STAFF REPORT

June 3, 2014

- a) **Case No. 12209-P-10**
- b) **Case No. 14471-P**
- c) **Case No. 14471-P-1**

PURPOSE: To allow for the removal of land from a prior plan and for the future construction of 169 single family homes.

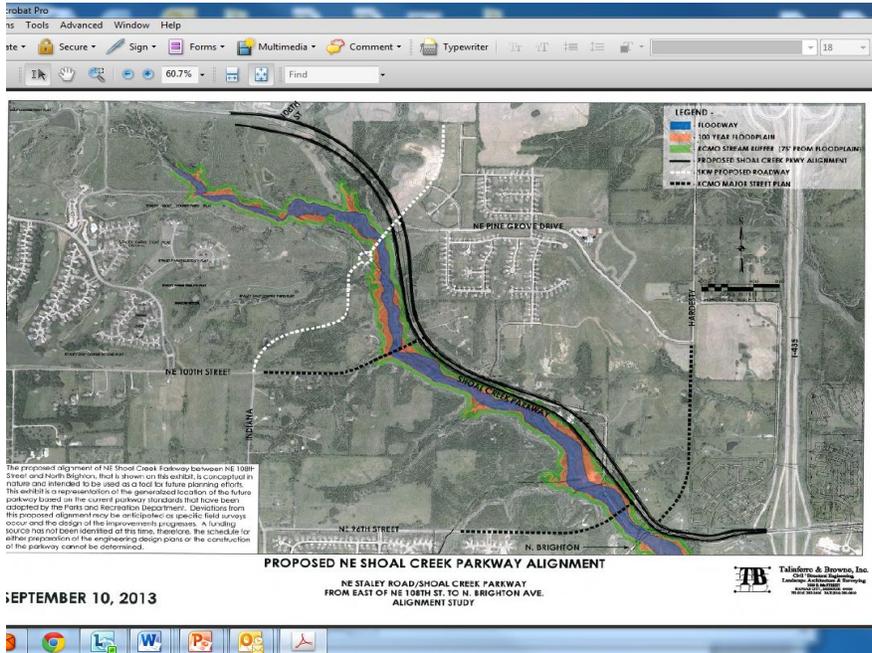
The proposed plan shows a 200 foot wide future Shoal Creek Parkway reserved (not dedicated) along the far western edge of the development. The applicant's representative states that this location is consistent with the Major Street Plan. In an analysis dated September 2013, City Parks and Recreation staff presented an alternative alignment to the Parks Board during a pre-Board workshop on September 10, 2013. The alternative plan, completed by the engineering firm Taliaferro & Browne, Inc. and endorsed by P&R staff proposes that the proposed alignment be shifted to the east, about 400 feet at the farthest point from the current plan alignment. If the plan were to be revised based upon P&R preferred alignment, the East Park plan would lose about 15 lots, unless the plan were revised to make these lots up in other locations. Parks staff provides the following time-line on the preferred alignment study. See below for a graphic of the preferred alignment.

** The East Park Subdivision sets aside 200 feet along their west property line. Their proposed alignment would force the construction of Shoal Creek Parkway to be built within the existing riparian corridor and within the 100 year flood plan, the floodway and stream buffer.*

** The Parks Department's preferred alignment locates the parkway to the east of the riparian corridor with minimal disturbance to occur within KCMO Stream Buffer and without any bridges.*

1. *The proposed Shoal Creek Parkway alignment, as shown on the development plan, must be modified to meet the Department's preferred alignment, as provided to the applicant's attorney in October 2013.*
2. *The developer must dedicate the right-of-way for the proposed Shoal Creek Parkway alignment, per the Department's preferred alignment, as it crosses through their property, as part of the platting process.*
3. *The development must include in the development plan a 50' wide landscaped no-build buffer along the Department's preferred alignment for the proposed Shoal Creek Parkway adjacent to their property.*
4. *The land being dedicated as private open space for parkland purposes must have a recreational use. Tract E for the proposed pool complex will not be accepted for this purpose until the pool is built.*

- h. The proposed Shoal Creek Parkway alignment, as shown on the development plan, must be modified to meet the Department's preferred alignment, as provided to the applicant's attorney in October 2013.
